Project: Upper Columbia River (UCR)

Subject: Proposed Modifications to Batching for UCR Long-Term Bioassay Samples

Figure 1. Proposed UCR long-term bioassay sample batching modifications considering mPECQ8.

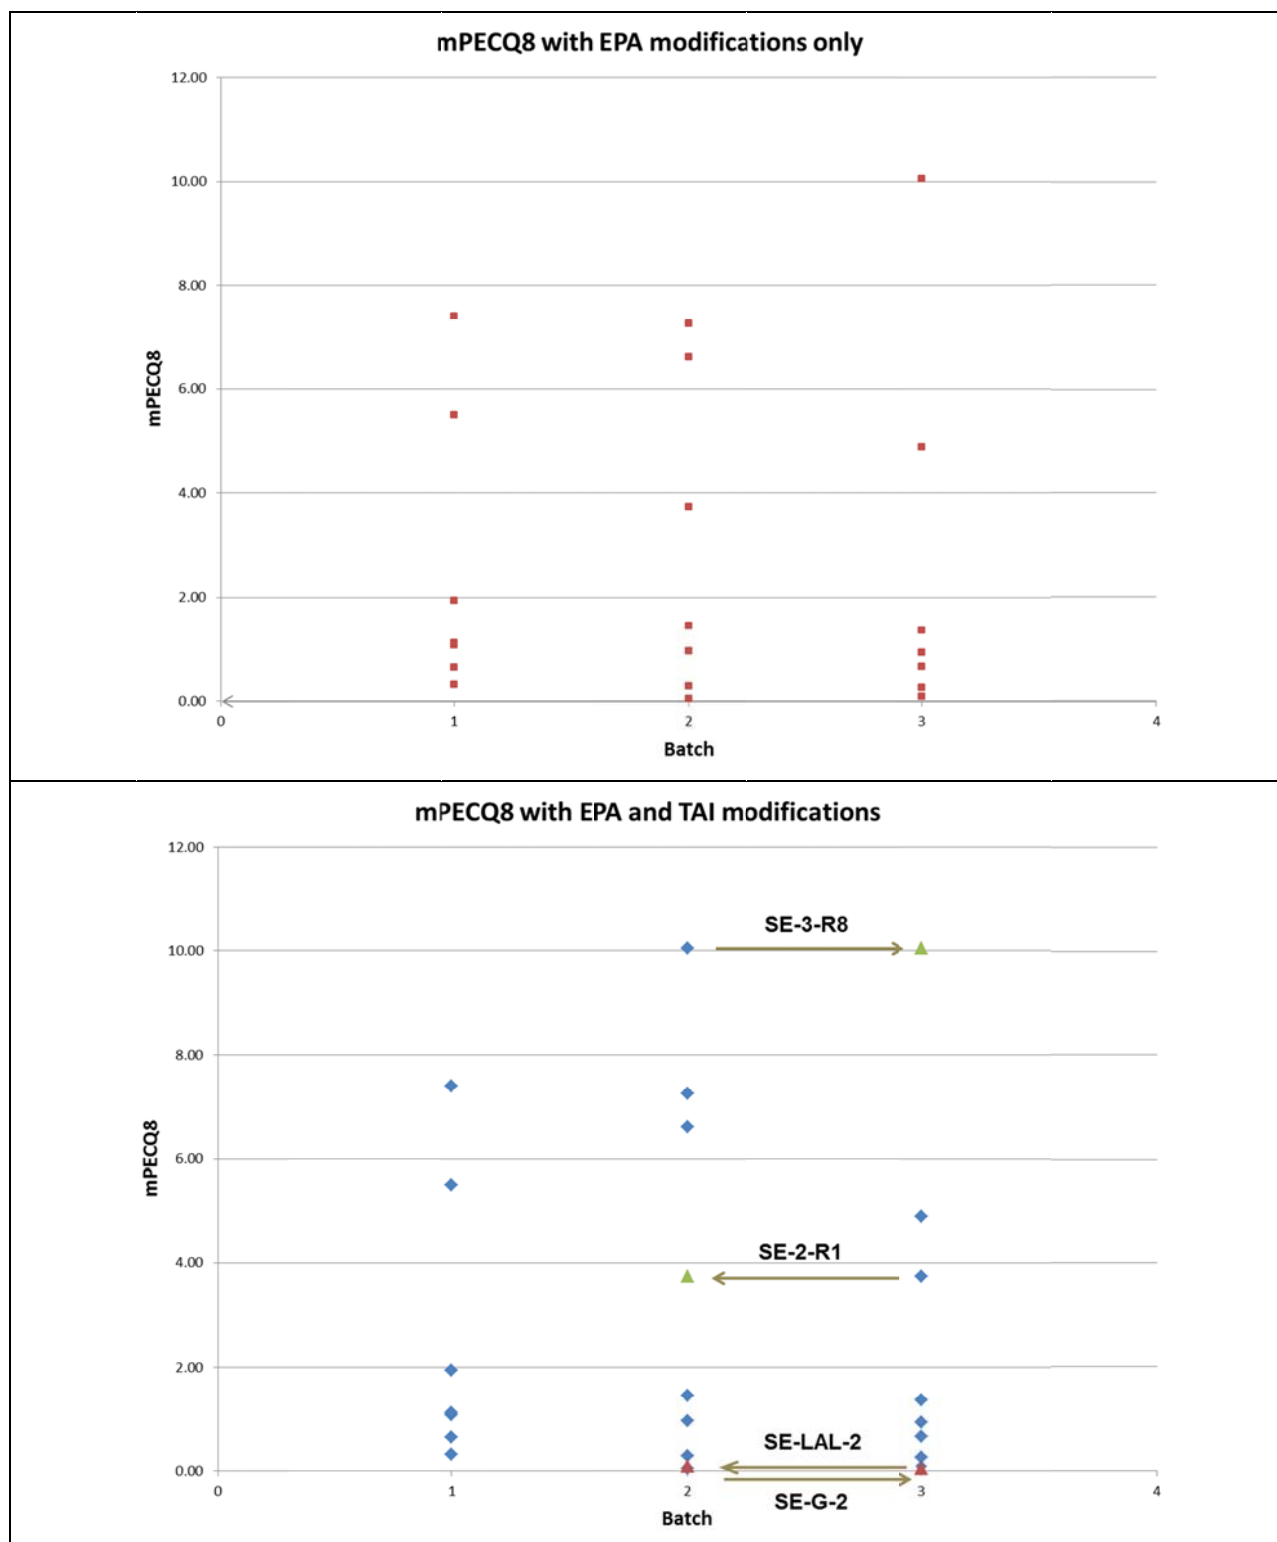
Recognizing that it may not be possible to fully balance all sediment properties across bioassay batches, the TAI team proposes to move Sample SE-G-2 from Batch 2 to Batch 3 and also move Sample SE-LAL-2 from Batch 3 to Batch 2. In addition to modifications for SE-3-R8 and SE-2-R1 proposed by EPA, the modifications for SE-G-2 and SE-LAL-2 attempt adjust the distributions and ranges of xSEM and TOC within and across batches. See Figures 1-3.
